# Spectral Isolation parameters for 802.3cw DWDM Black Link

Eric Maniloff - Ciena

IEEE P802.3cw

May 23, 2022

Figure 156-3—Black link example configuration for specifying  $n$  DWDM channels

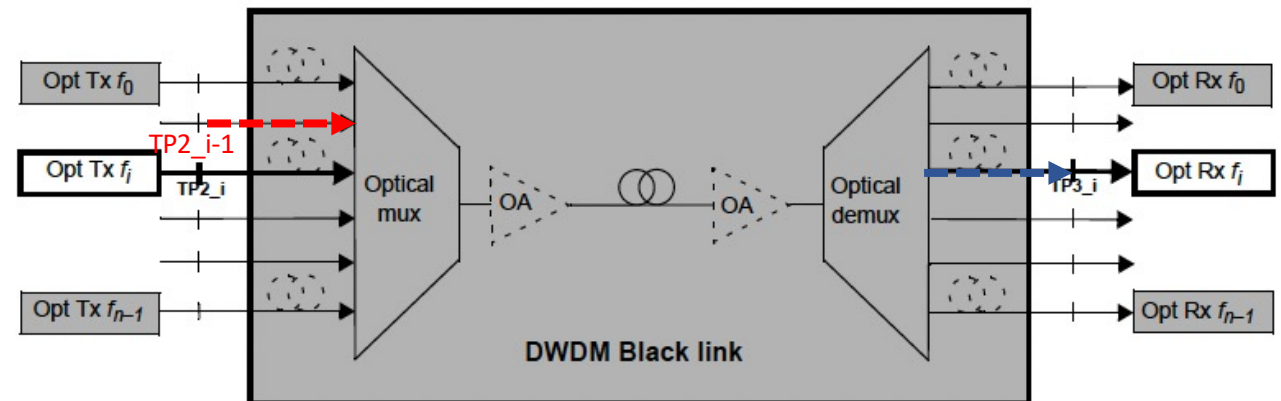
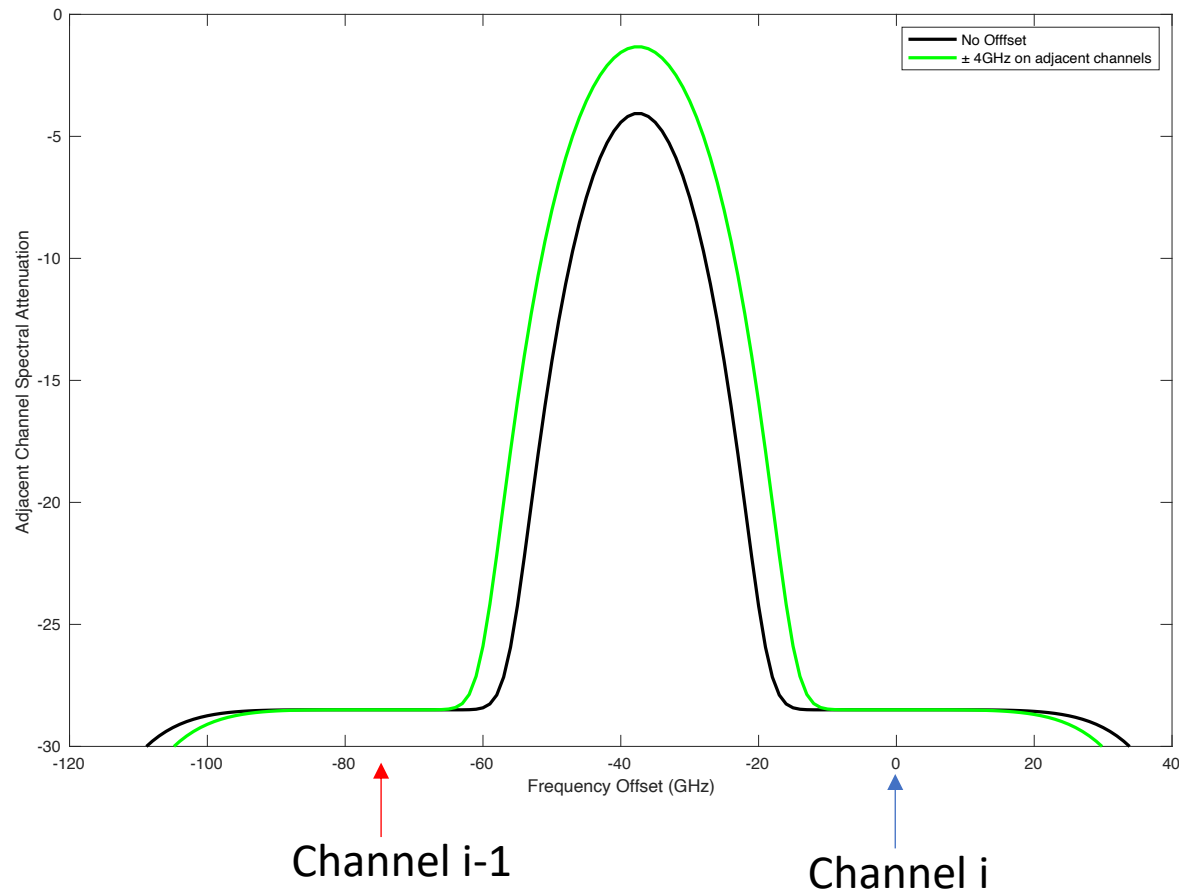
- Spectral Isolation from TP2\_i-1 to TP3\_i: The Green curve shows the worst case for adjacent channel spectral isolation based on slide 6 parameters

- Specification values:
  - The spectral attenuation from an adjacent channel frequency divided by the attenuation at the center frequency of a signal channel will be less than the values presented in the table at the right
- The TBD values in Table 156-9 in 802.3cwD1p5 should be replaced by these values

Frequency Offset	Isolation (dB)
0	-28.5
±15	-25.9
±20	-15.9
±25	-8.0
±30	-3.5
±35	-1.6
±40	-1.6
±45	-3.5
±50	-8.0
±55	-15.9
±60	-25.9
±65	-28.5
±70	-28.5
±75	-28.5
